AMENDMENT TO OPERATING LICENSES NPF-4 AND NPF-7
NORTH ANNA POWER STATION UNIT NOS. 1 AND 2
PROPOSED TECHNICAL SPECIFICATION CHANGE

SAFETY EVALUATION FOR A REVISED $F_{\Delta H}^N$
 PART POWER MULTIPLIER
 FOR NORTH ANNA UNITS 1 AND 2
 OPERATION WITH A RCS TAVG OF 587.8°F

FIGURE 1

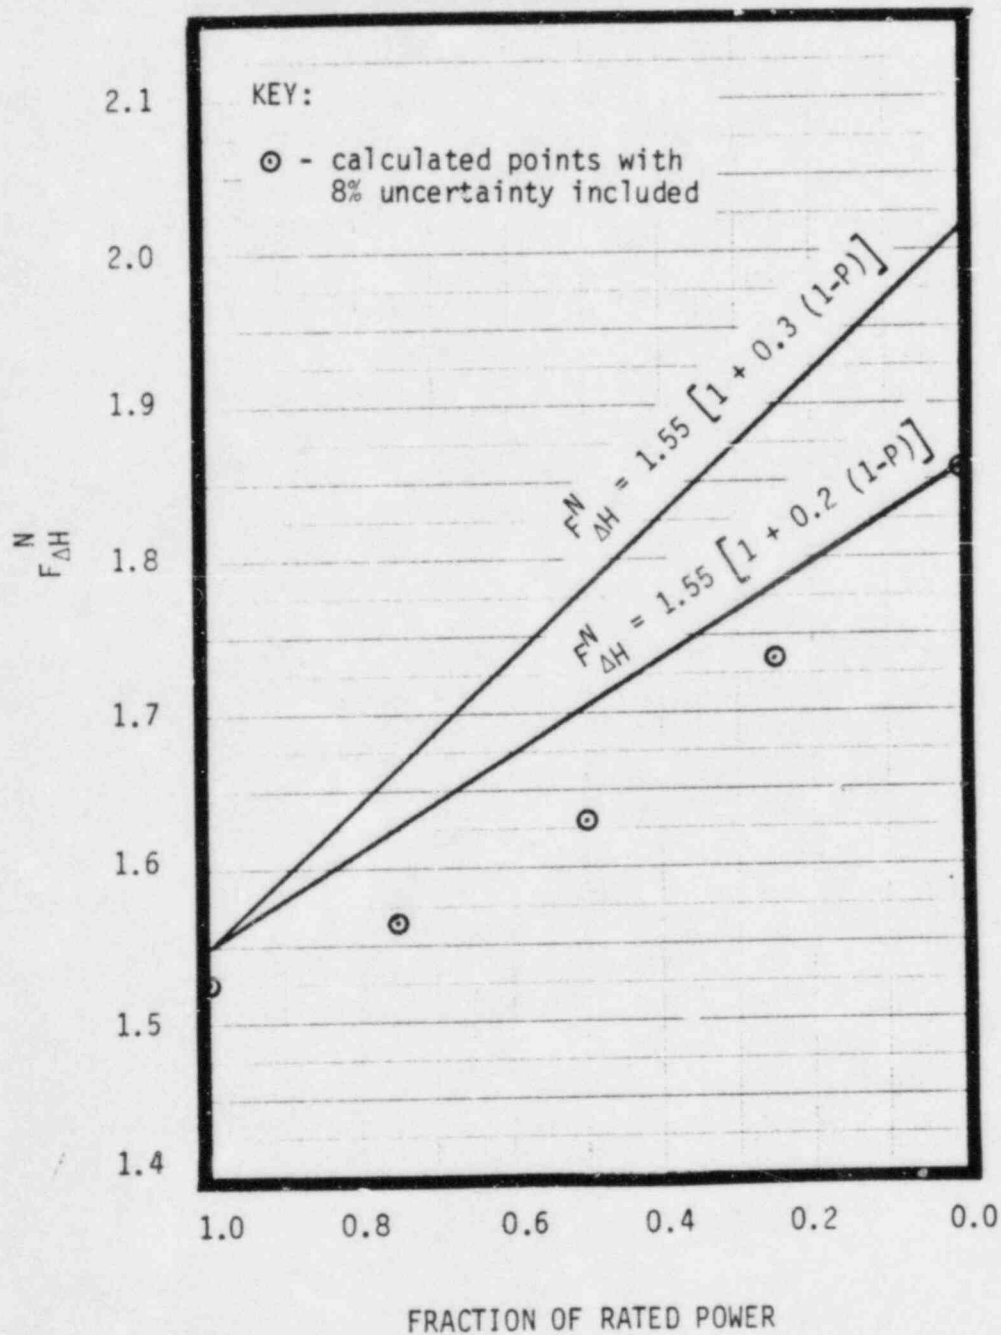
This change is requested for North Anna to allow optimization of the core loading pattern by minimizing restrictions on $F_{\Delta H}^N$ at low power. This change will also minimize the probability of making rod insertion limit changes to satisfy peaking factor criteria at low power with the control rod banks at the insertion limit. Figures 1 and 2 show the calculated values of $F_{\Delta H}^N$ versus core power for North Anna Unit 1 Cycle 4 and North Anna Unit 2 Cycle 3, compared to the current and proposed Technical Specification limits on $F_{\Delta H}^N$.
